Ingen Consulting
Alstonville NSW 2477
0417 264 987
michiel@ingenconsulting.com.au
www.ingenconsulting.com.au

Our Reference: J1065 letter 290721

Re: Response to Statement of Facts and Contentions Case number 2021/00026242

Riverbank Quarry
Response to Statement of Facts and Contentions

## ANNEXURE G - NOISE BERM CONCEPT ENGINEERING DRAWING

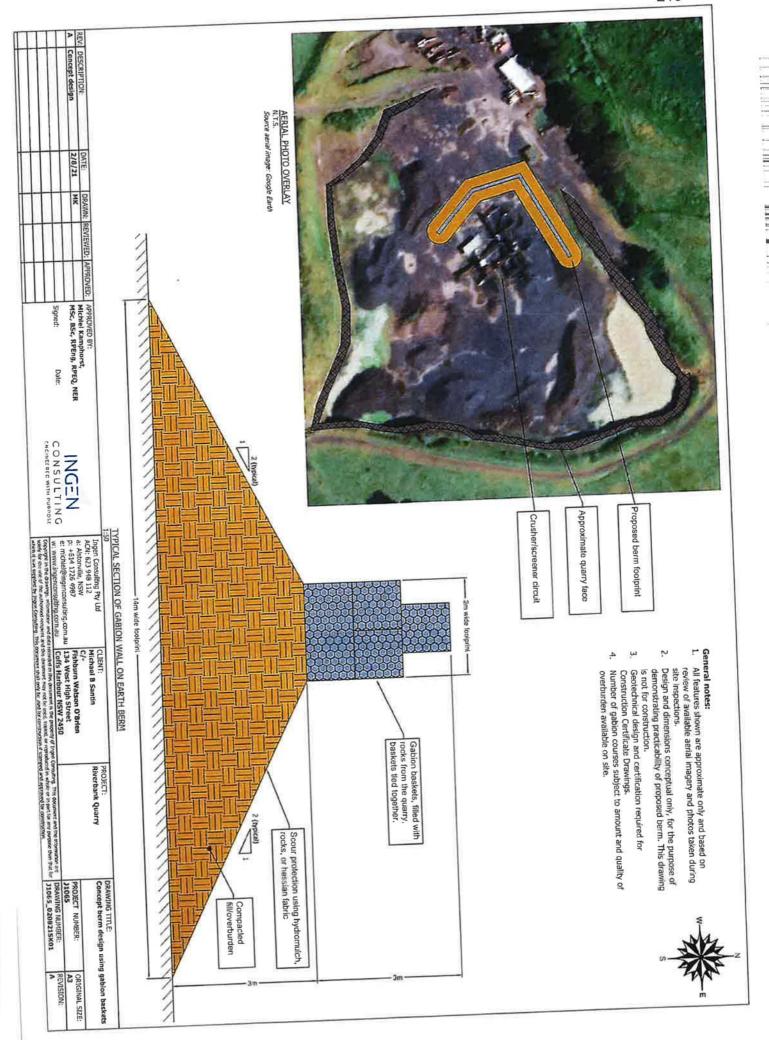
98		Common practise is to provide those details with the Construction Certificate Application.
8c	ed with the	The purpose of the berm is to interrupt the 'line of sight' between the receivers to the north/northwest and the quarry equipment. As such one would expect the berm to improve the visual aspect of the quarry overall.
P8	There is no engineering information provided to demonstrate that a 6m high "berm" (presumably constructed from earthen materials) could be safely constructed within the area shown on the plan. The berm shown on Figure 11 Page 16 of Council's assessment report scales at about 7.2m wide at the base. A 6m high earthen berm with external slopes of one vertical to three horizontal for maintenance would have a base width of almost 40m, meaning that it would occupy a considerably larger area of the quarry floor than was depicted in the proponent's figure.	The assertion that the berm base width is 7.2m is incorrect. The modelled base width is 14 metres.  No engineering information was provided with the report as this was assumed to be self-evident. Typically, construction information for specially designed berms would be provided with a Construction Certificate Application.  We have now prepared a detailed concept engineering drawing for this wall, provided in Annexure G.

Location of crusher, screen and berm (Ingen 2021)

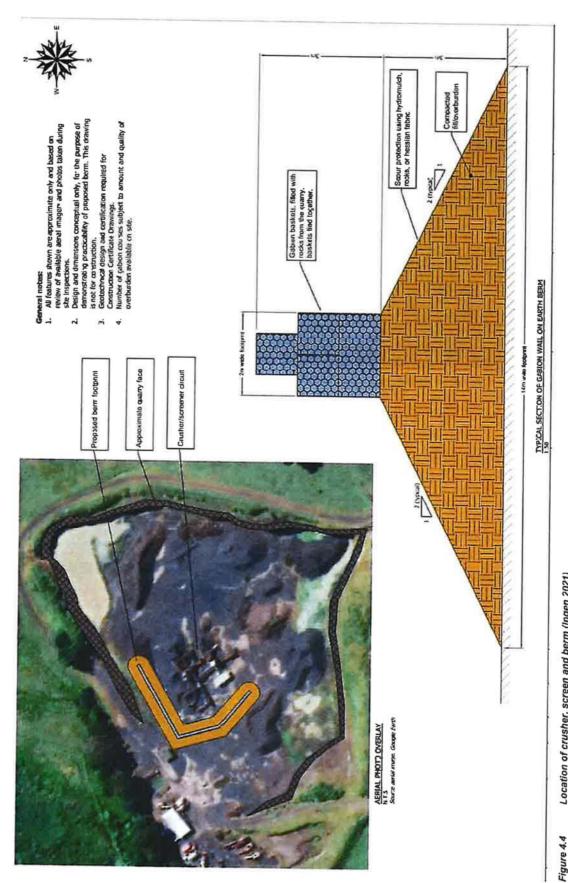
7.0	The Noise Assessment relies on a variety of ad hoc noise mitigation measures. These include covering plant and equipment with insulation material, placing rocks in the hopper is rather than dropping from a height, and having the crusher and screening equipment operating in a similar manner to operations which were apparent during noise testing. These are not practical measures for long term quarry operations.	The mitigation measures adopted are practical for long term operations. No justification has been provided in contention 7b why these measures would not be practical. If insulation materials wear down over time they can easily and quickly be replaced with new material. The manner of placing rocks in the hopper is managed by BMP toolbox talks as described in 7a above. Refer to the response to 7a for more detail about the use of Best Management Practises.
00	full	The report contains sufficient information on key noise mitigation measures, this is detailed in the responses to be sub-contentions below.

N9	When not in use, vehicles and machinery will be turned off.	Quarry Operator		
N10	Cover noisy parts of the crusher and screen with insulation material, see Figure 4.3.	Quarry Operator		
N11	Rocks to be carefully placed in the hopper and trucks, rather than being dropped in from a height.	Quarry Operator		
N12	Crushing and screening operations to be similar to what was done during the attended testing day of the 12th of March 2020;  Insulation covers over loud machine components of the crushers and screens, see Figure 4.3.  Gentle placement of rocks in the hopper.	Quarry Operator		
Monito				
N13	Routine weekly inspections will occur throughout the operational lifetime of the quarry to identify any ad-hoc noise issues such as faulty equipment, noisy works.	Quarry Operator		
N14	Berms are to be inspected monthly to ensure they remain in good condition and meet the requirements outlined in N6.	Quarry Operator
